DEVELOPMENT REVIEW BOARD
SUPPLEMENTAL SUBMITTAL

PROJECT NO. 8/21/2020
Application No. PR-2020-004030/ SD-2020-00540

SUBMITTAL DESCRIPTION: Plan Updates and response to comments

TRACT D-1 & E-1 CONCEPT
 PARADISE HEIGHTS, UNIT 1
 ALBUQUERQUE, NEW MEXICO

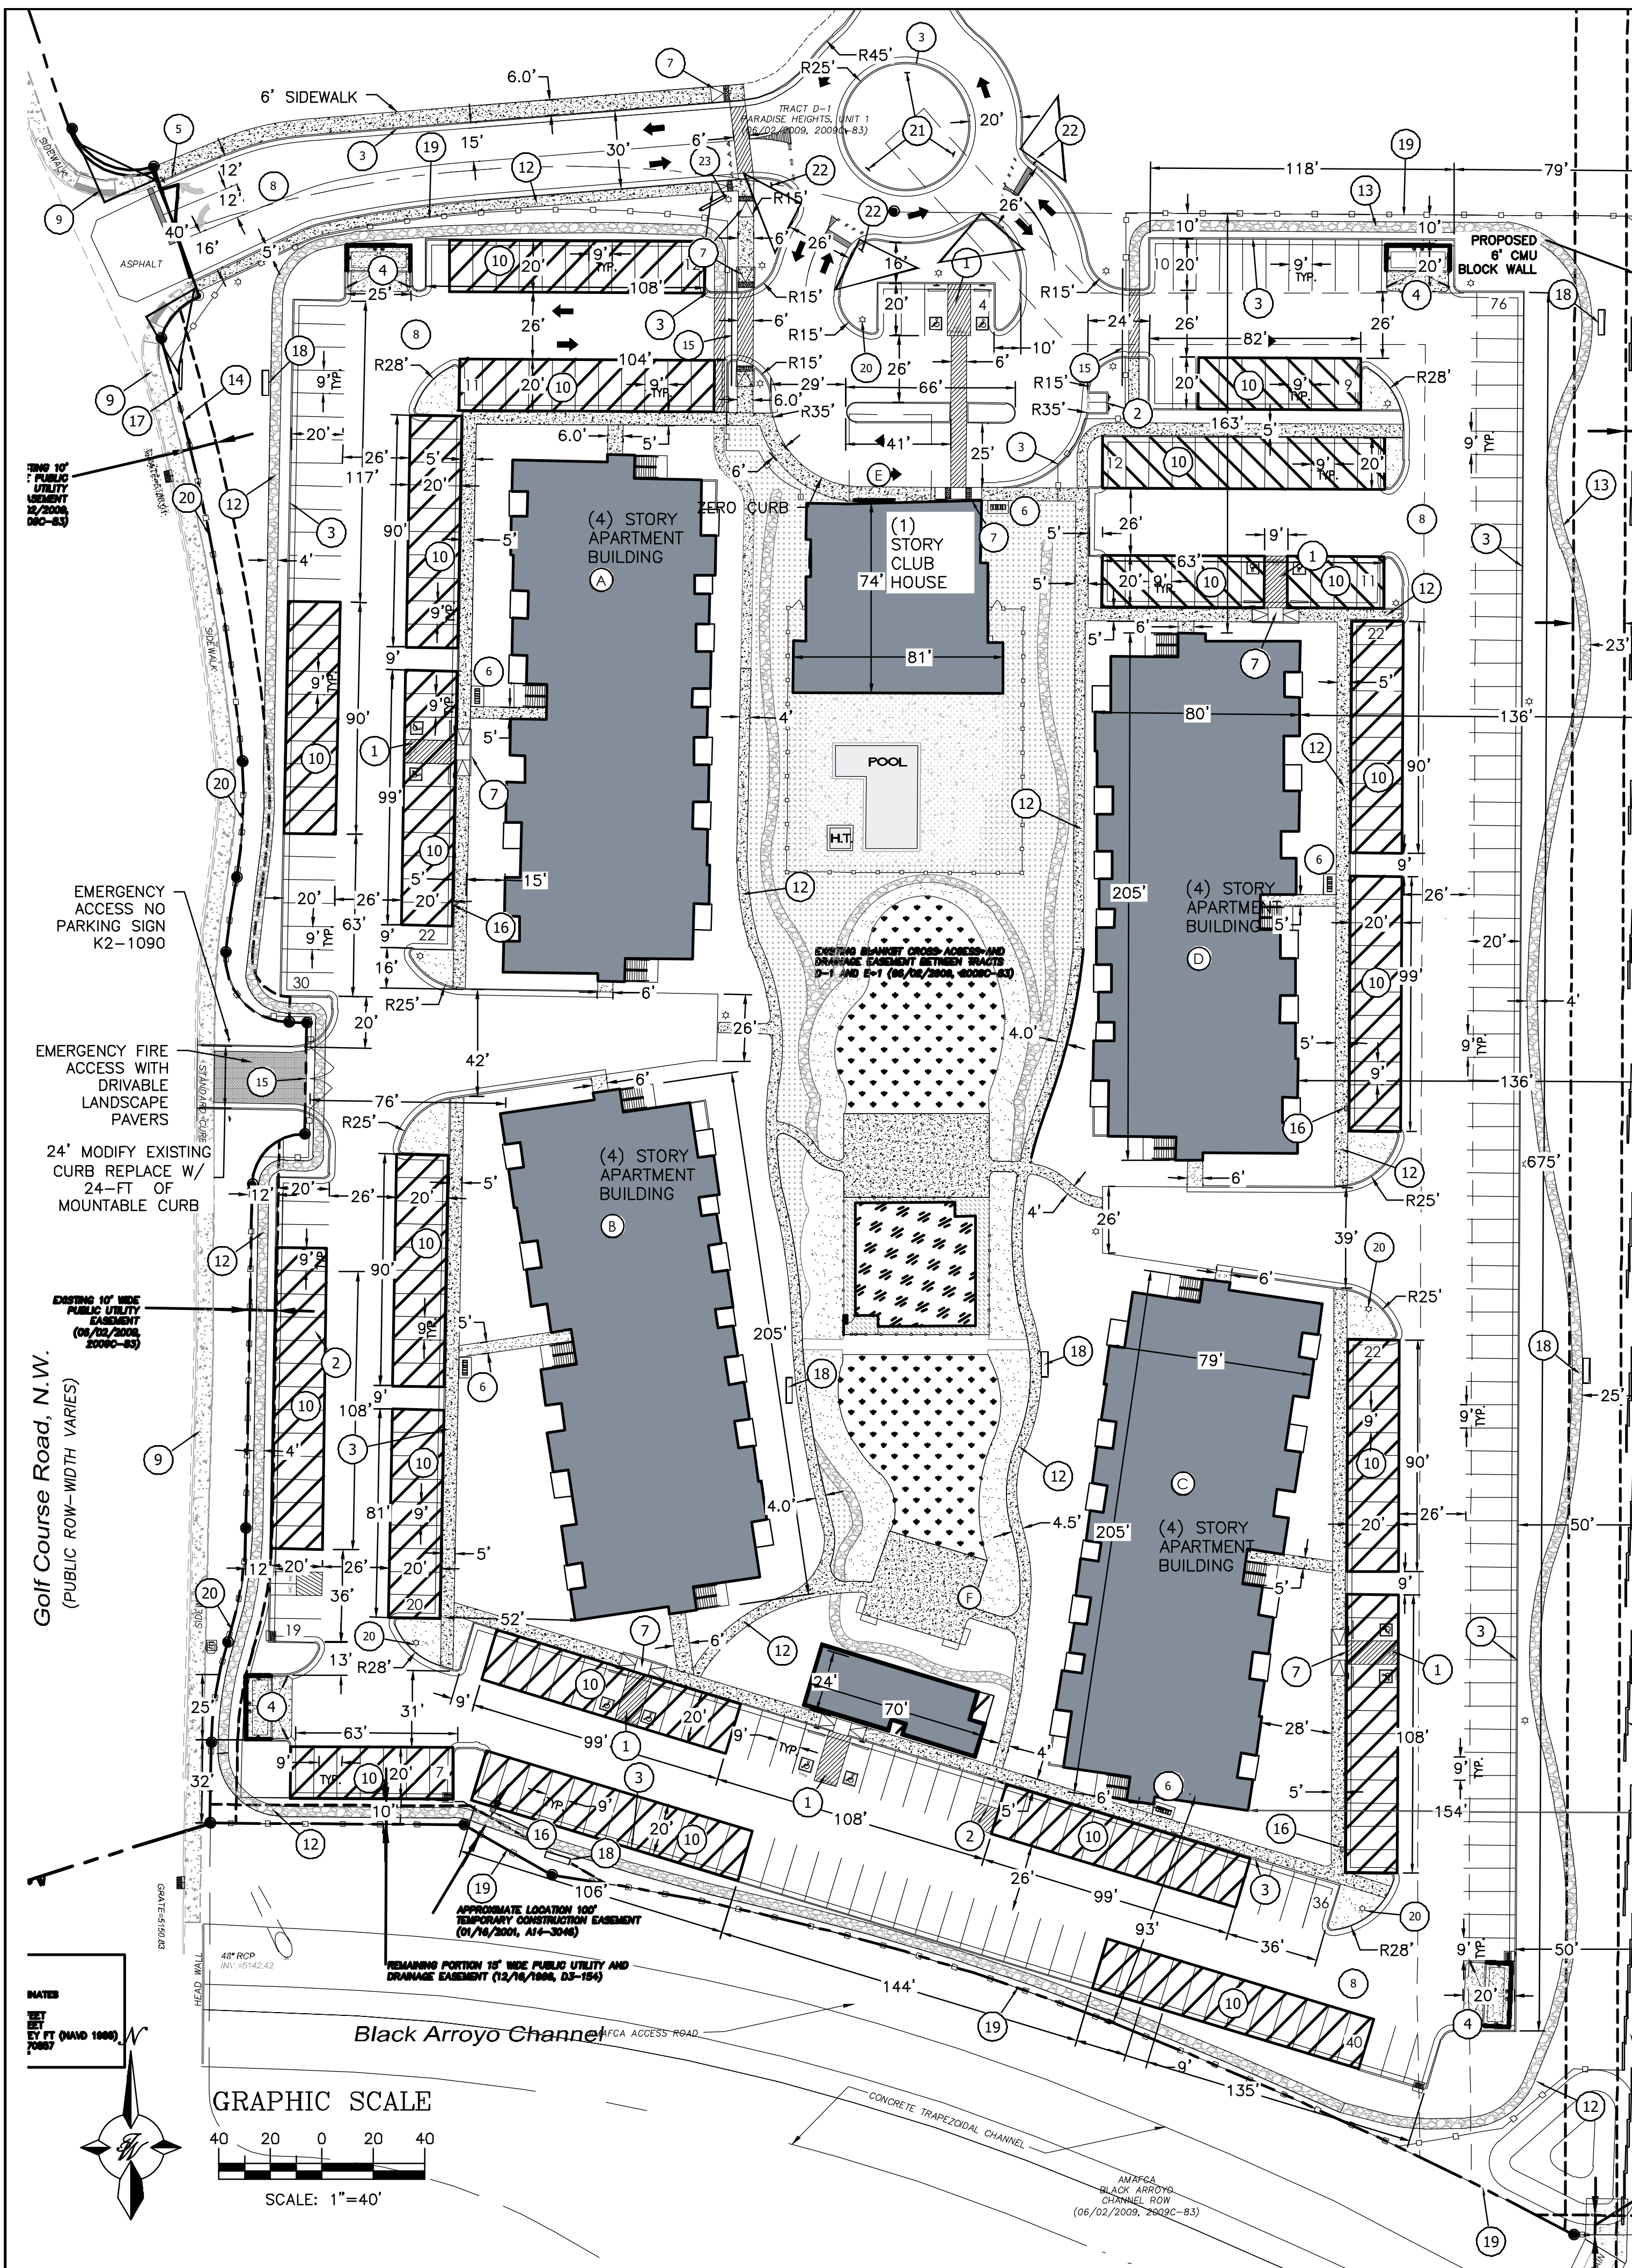
1. Serviceability Letter #200506 has been written and provides the conditions for service.
2. The property is outside of the Adopted Service Area. A Water Authority Board approved development agreement will be required prior to Site Plan approval. The serviceability letter will serve as an exhibit to the development agreement.
3. Utility Plan – **Plan Updated**
 - a. Please label the existing public sanitary sewer along the southern frontage.
 - b. Label the proposed private sanitary sewer along the southern property line.
 - c. Note indicates 20’ private exclusive easement for public sanitary sewer which is not correct.

Response: Refer exhibit 2020013 D-1 & E-1 Concept SAS layout 8.5.20 showing coordination with future D-1 property development.

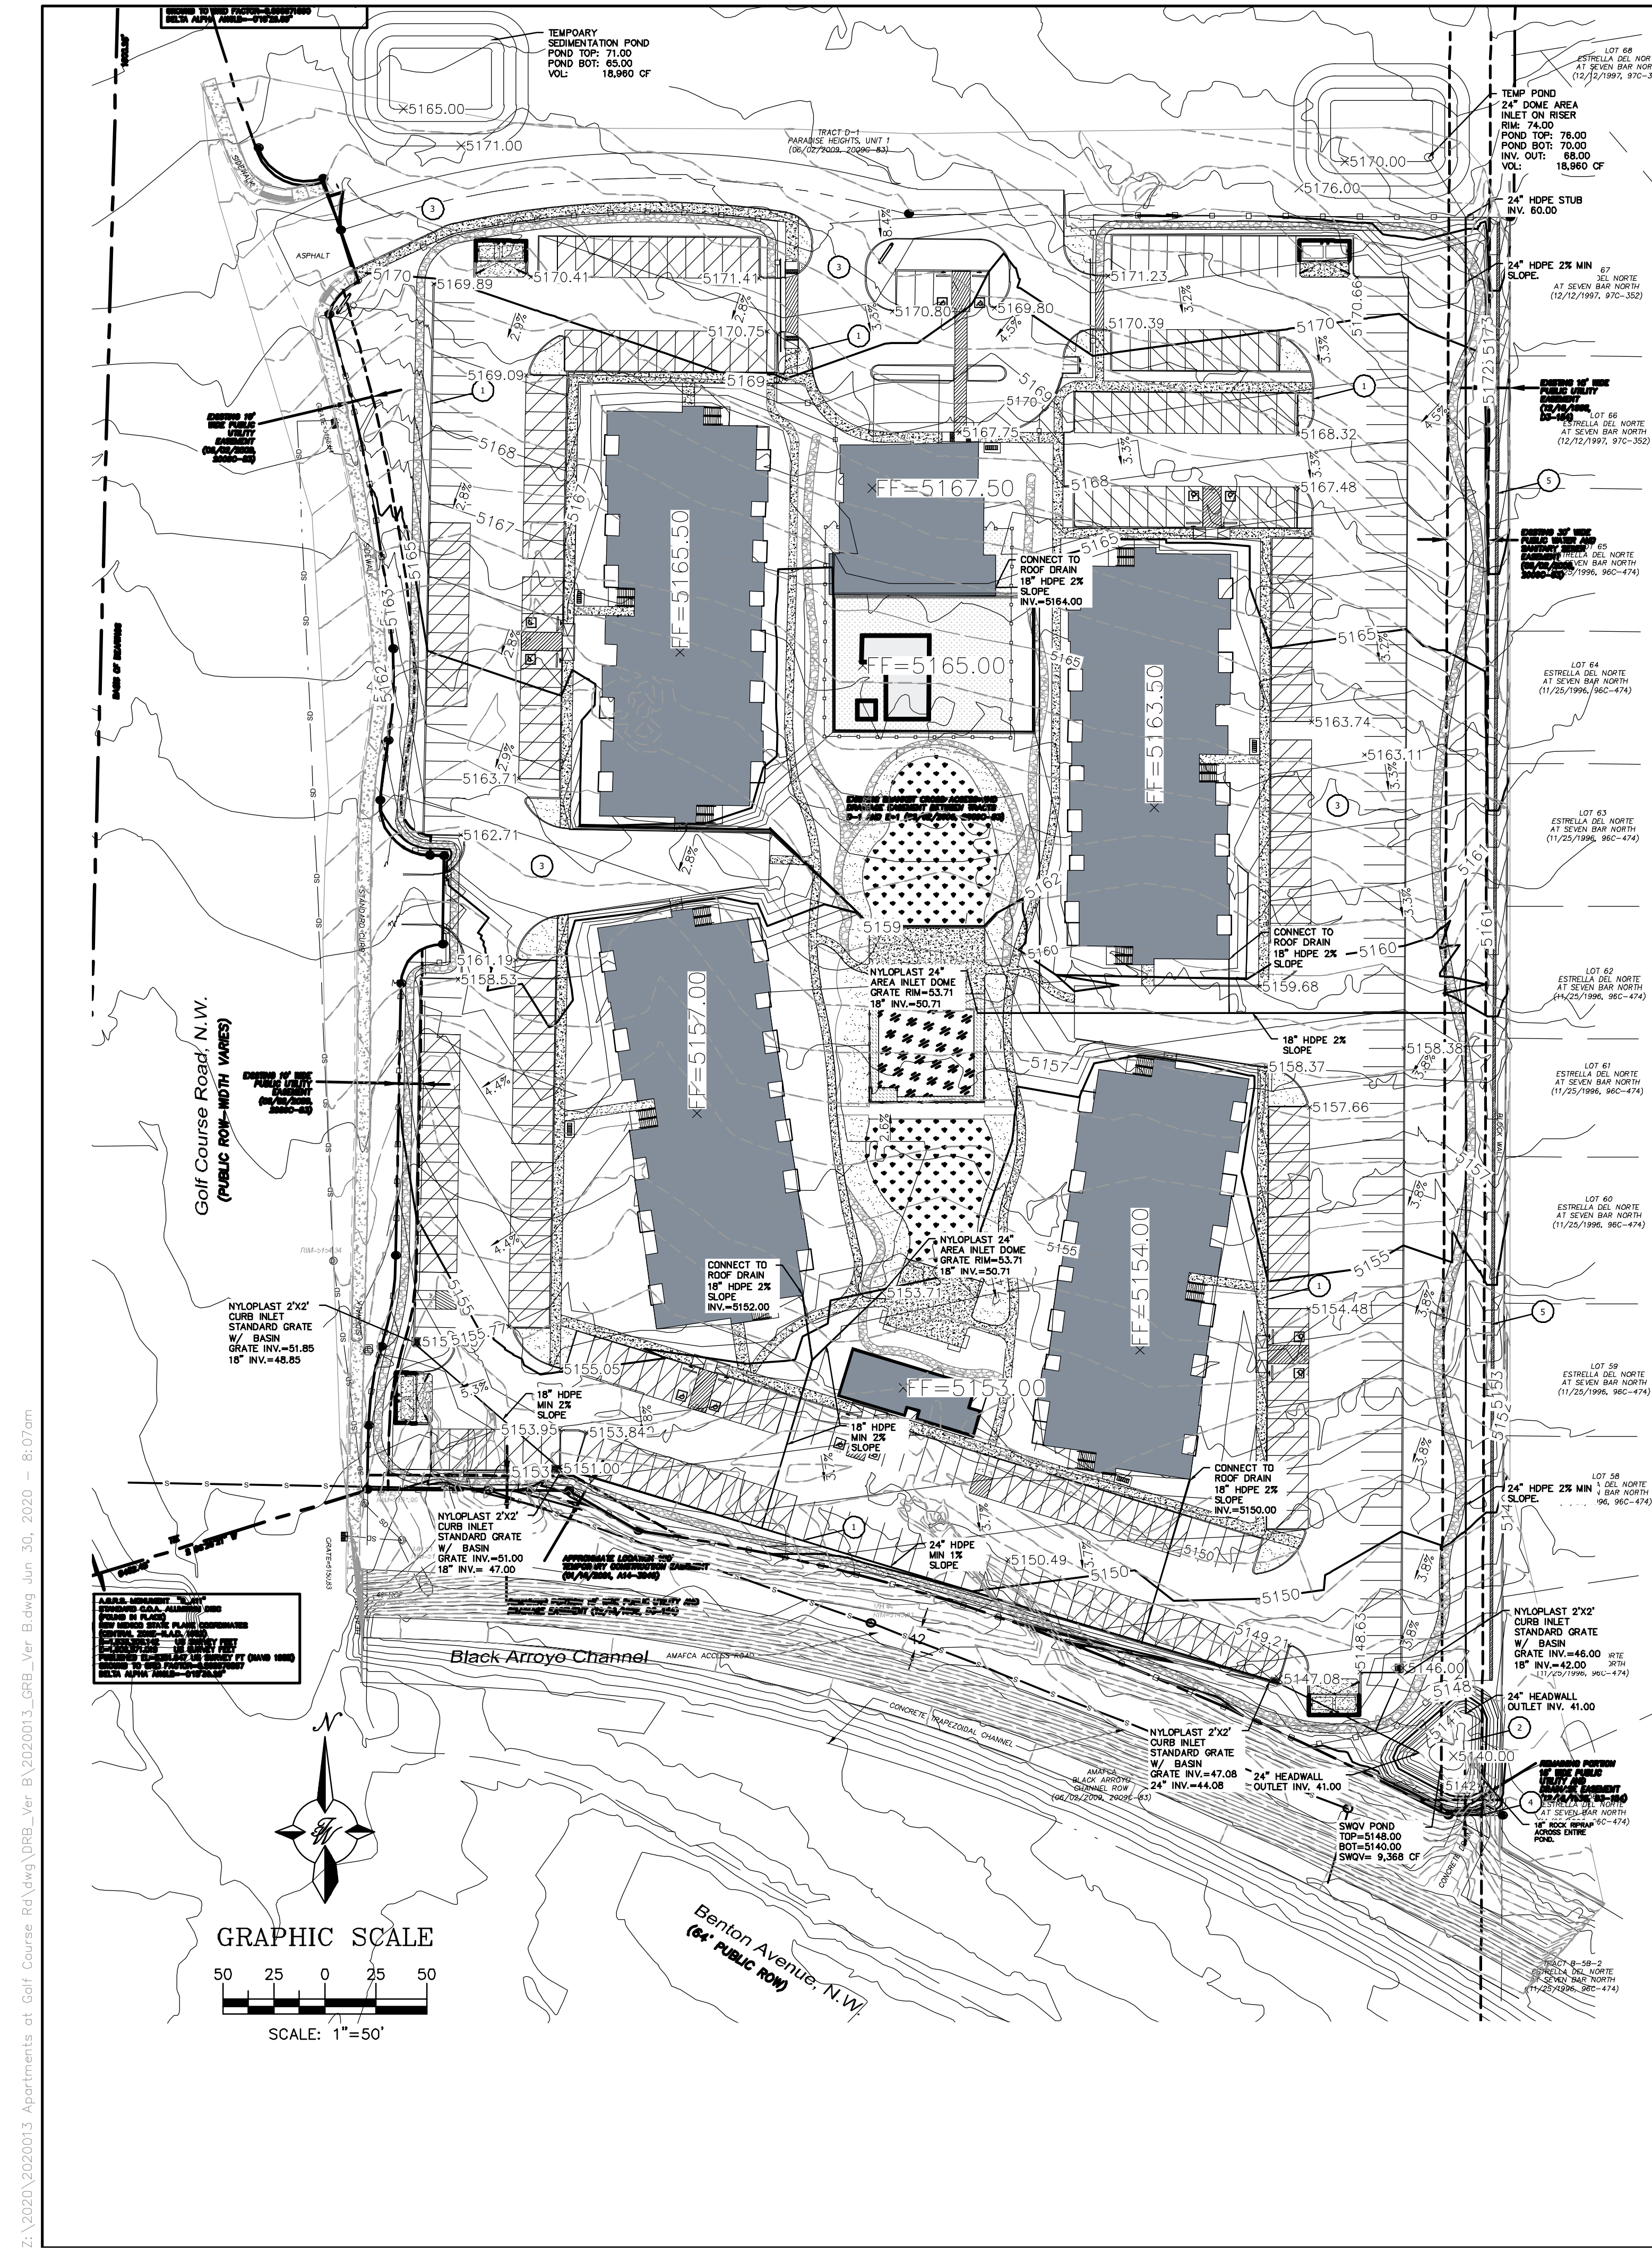
- 1) **Please verify that fence will be 3 ft.**
- 2) **CE has reviewed this plan for compliance with the IDO and has no objections.**

The wall height along Golf Course Road frontage is 3-ft in height, per label 20, on sheet C-1, per the IDO requirements on Table 5-7-1.
